MEMORANDUM

DATE: June 22, 2023
TO: City of Washington, IL
FROM: Howard Hamilton, PE, CFM, CPESC
SUBJECT: Alternative Analysis, Draft Concerns/Updates and
Smoke Test Discussion
HCE # 21911

ALTERNATIVE ANALYSIS

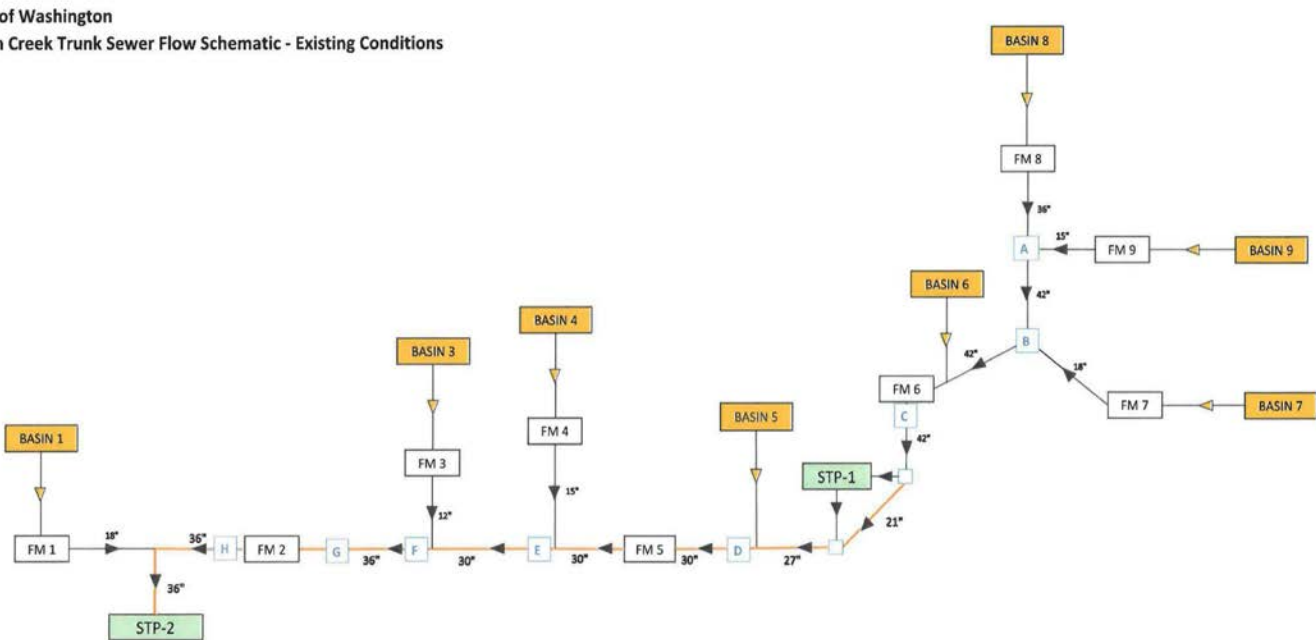
As noted during the March 20, 2023 City Council Meeting, and discussed on page 27 of the “Farm Creek Trunk Sewer 3rd Party Alignment Analysis”, prepared by HCE, the alignment of the E-3 sewer routing presented in the report differs from that originally recommended by Aptim/Goat Springs, LLC. In our professional opinion, the shift was done to better the proposed alignment in cost, ease of construction, acquisition of easements, impact upon future use of the properties, and ability to extend service to the sewer in the future.

The shift in alignment was done to avoid routing the sewer through the middle properties, instead favoring a route that followed property lines. The Aptim alignment cuts across the middle of three properties and the corners of two additional properties. Easements will be needed both for construction and for long-term ownership and maintenance. The Aptim sewer is located further south than our suggested alignment, nearer the creek and is therefore shallower, which may result in less expensive construction. However, the long-term use and development potential of each of these properties will be severely impacted. During the appraisal and negotiation of easements, the sewer location and how it may restrict current and future uses of the property are considered. The Aptim alignment represents a significant imposition on the landowners and future growth of the city, which is likely to result in a longer and ultimately more costly land acquisition process. Sewer alignments that follow property lines naturally present less of an imposition on property owners and their future development potential, and the associated easements can therefore be easier to obtain.

As shown on the following page, by shifting the alignment north, HCE runs the sewer east along a common property line rather than through and across various parcels. This shifts the alignment for approximately 0.7 miles out of the total 2.25 mile long sewer construction and lessens the imposition on the property owners, which should aid the City in the negotiation and acquisition of easements should this alignment be selected.

Figure 2.02-2 Existing System Flow Schematic

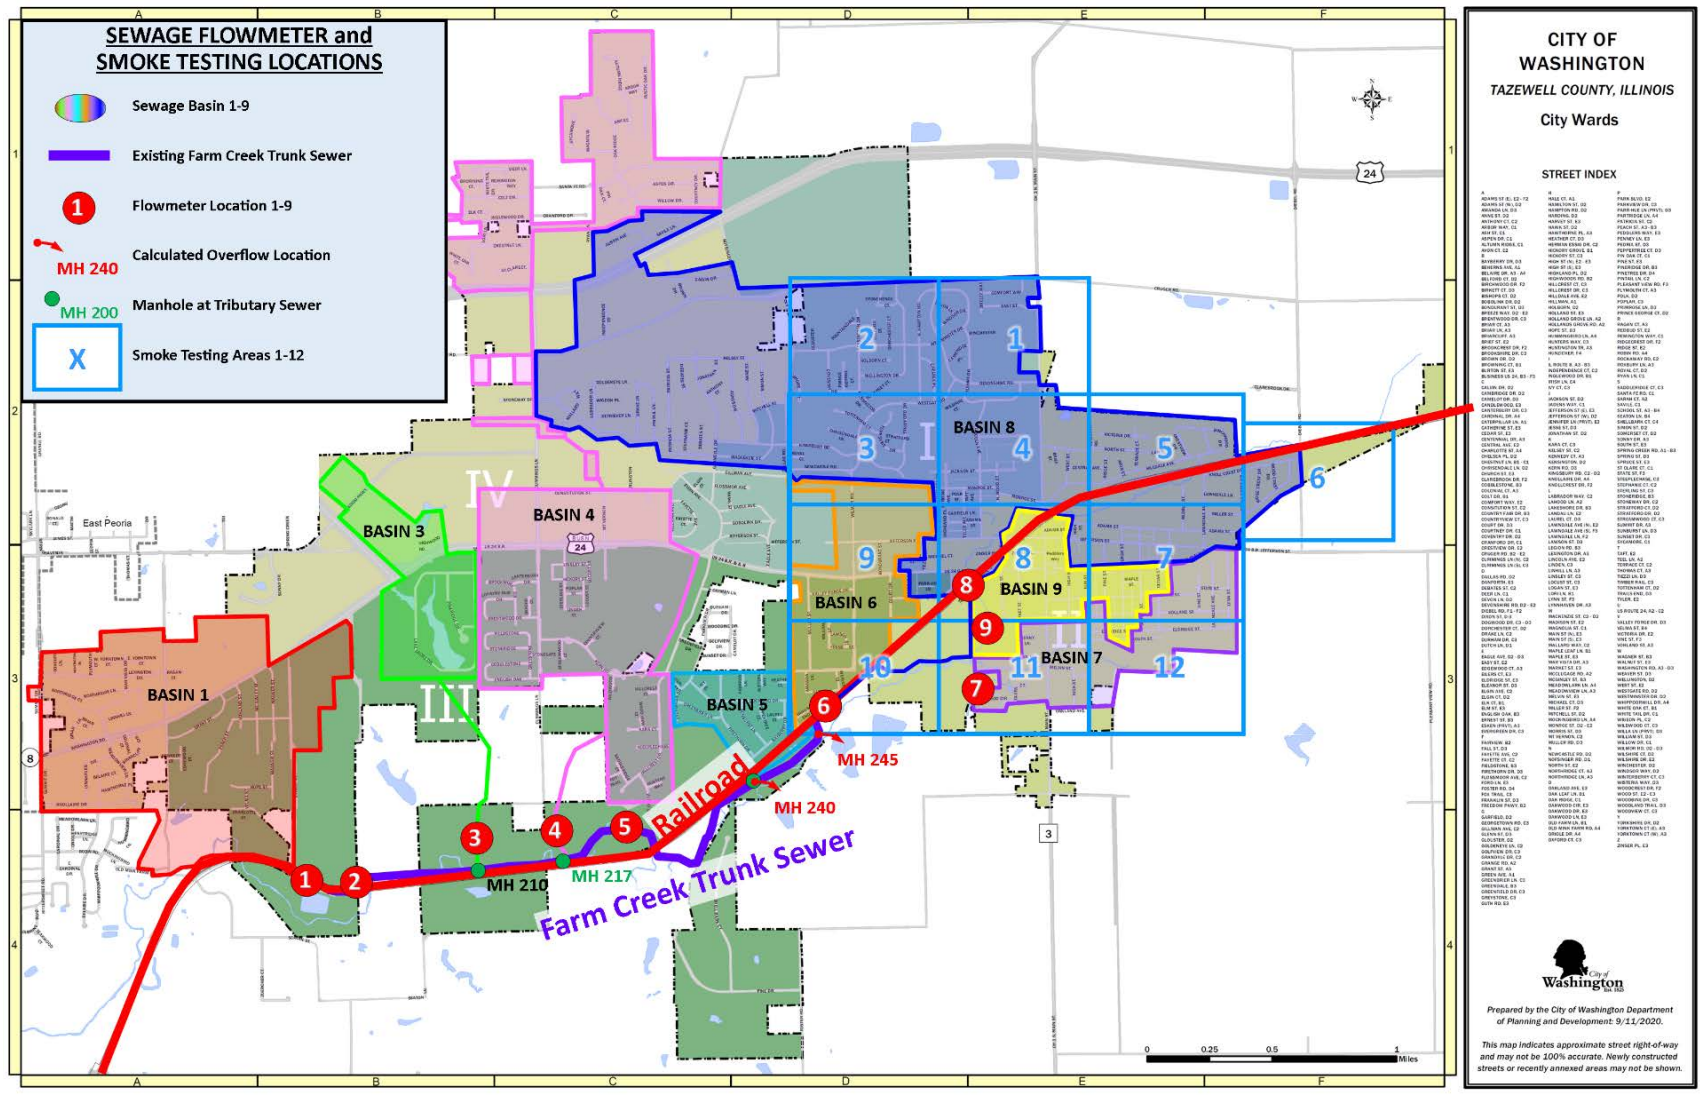
Evaluation of the information provided in Table 3.02-1 of the Strand Report revealed that the city is subject to flows of 16.92 times average flow with three most severe basins being Basin 7 with a peaking factor of 56.10, Basin 9 with a peaking factor of 43.47, and Basin 5 with a peaking factor of 56.10. HCE created a summary table of the information, a portion of which follows:
